SUNDRY NOTICES AND REPORTS ON WELLS (DO NOT USE THIS FORM FOR PROPOSALS TO DRILL OR TO DEEPEN OR PLUG BACK TO A DIFFERENT RESERVOIR. USE "APPLICATION FOR PERMIT" (FORM C-101) FOR SUCH PROPOSALS.)		WELL API NO. 30-025-41464
1. Type of Well: Oil Well ☒ Gas Well ☐ Other ☐ HOBBS OCD		5. Indicate Type of Lease STATE ☒ FEE ☐
2. Name of Operator EOG Resources, Inc.		6. State Oil & Gas Lease No.
3. Address of Operator P.O. Box 2267 Midland, TX 79702		7. Lease Name or Unit Agreement Name Dragon 36 State
4. Well Location Unit Letter <u>N</u> <u>220</u> feet from the <u>South</u> line and <u>2458</u> feet from the <u>West</u> line Section <u>36</u> Township <u>24S</u> Range <u>33E</u> NMPM County <u>Lea</u>		8. Well Number <u>10H</u>
11. Elevation (Show whether DR, RKB, RT, GR, etc.) 3473' GR		9. OGRID Number 7377
		10. Pool name or Wildcat Red Hills; Upper Bone Spring Shale

EOG Resources requests an amendment to our approved APD to reflect a change in BHL and TD.

Well Name: Dragon 36 State No. 10H

Dragon 36 State #10H
Pitchfork Ranch
Lea County, New Mexico
Revised 10/16/14
Proposed Wellbore

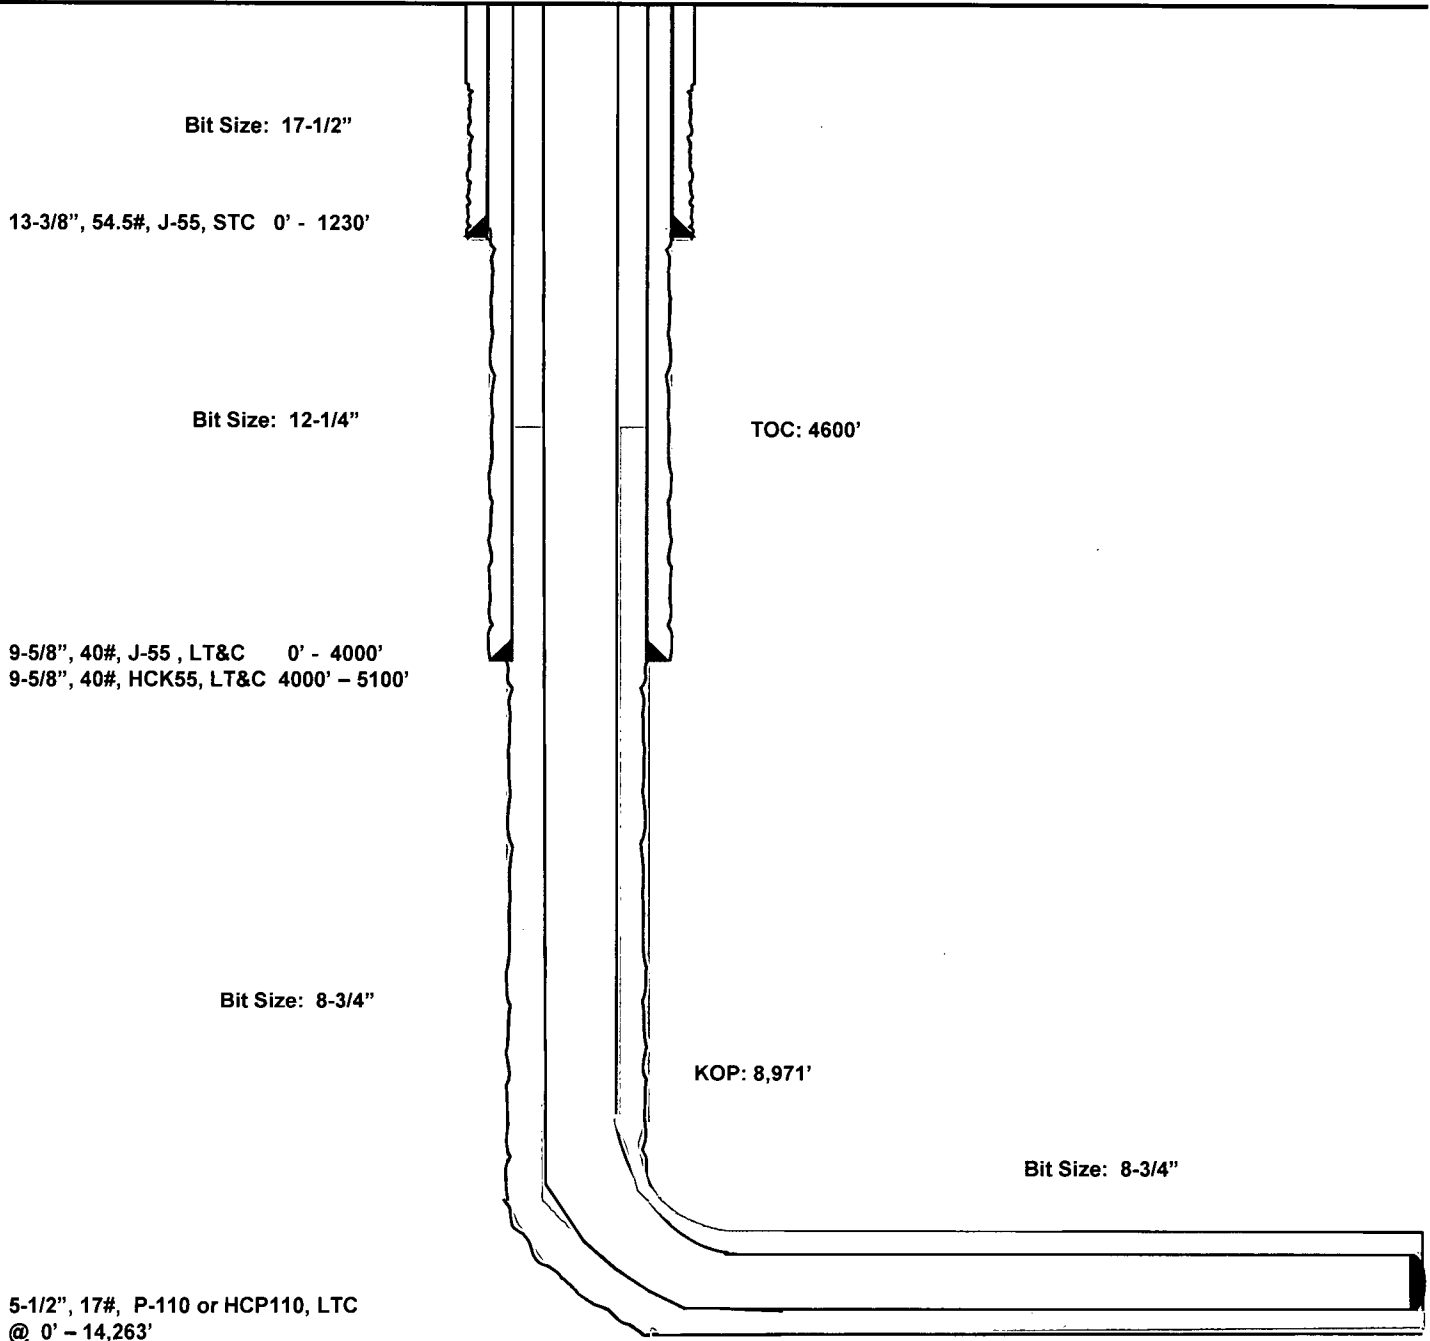
The new BHL is 230' FNL & 2452' FWL, U/L B, Section 36, T24S, R33E.
The new TD is 14263' TMD, 9450' TVD.

Lateral: 14,263' MD, 9,450' TVD

BH Location: 230' FNL & 2452' FEL
Section 36
T-24-S, R-33-E

Lea County, NM (NAD 27 NME)
Dragon 36 State #10H
H&P 260
Plan #1

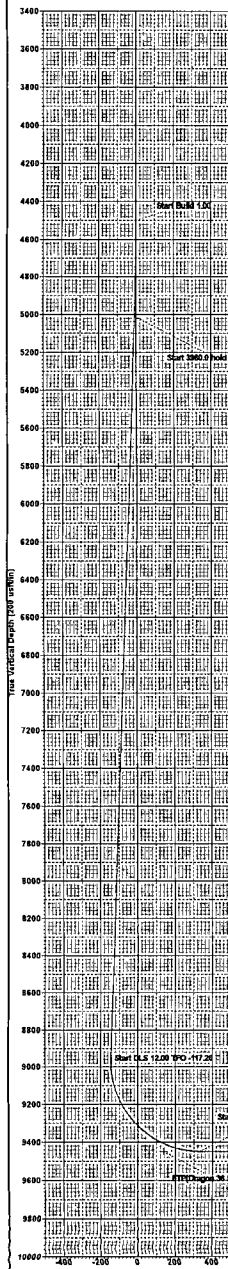
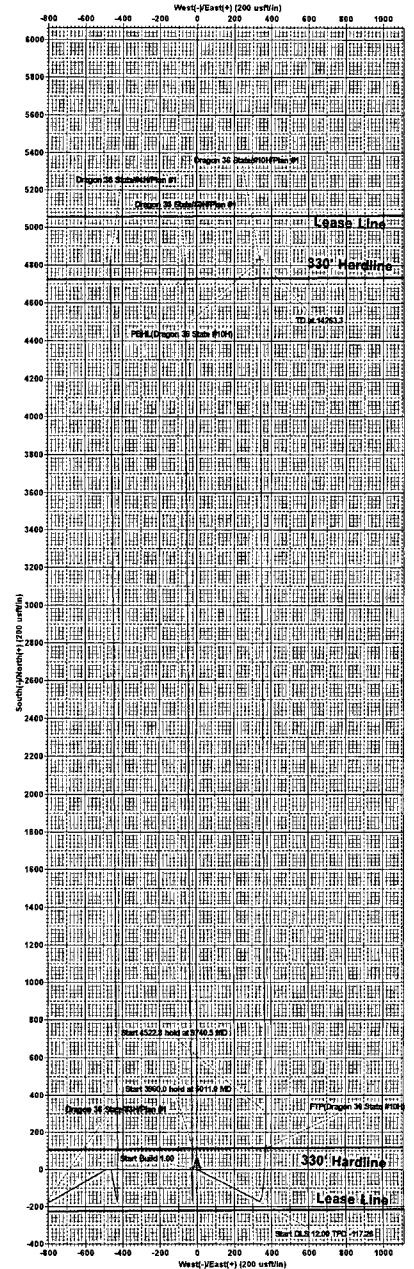
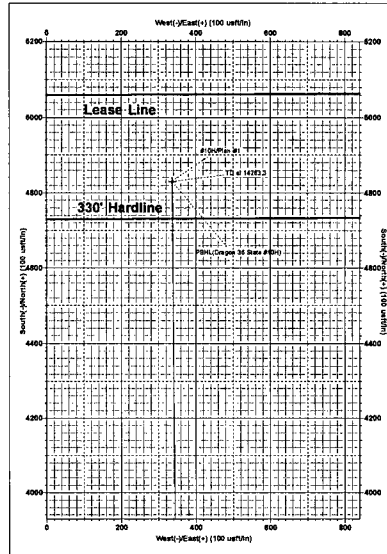
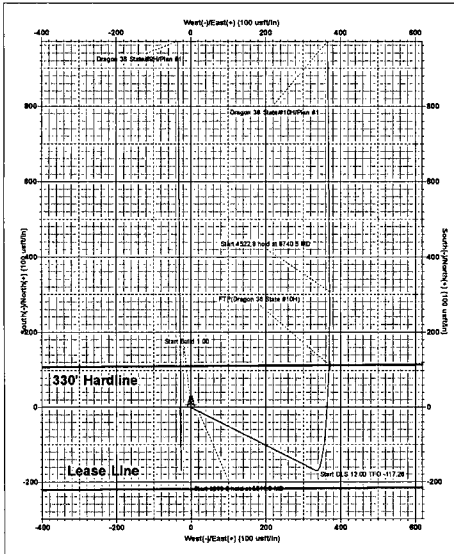
A revised C-102, directional plan, and drill plan are attached.
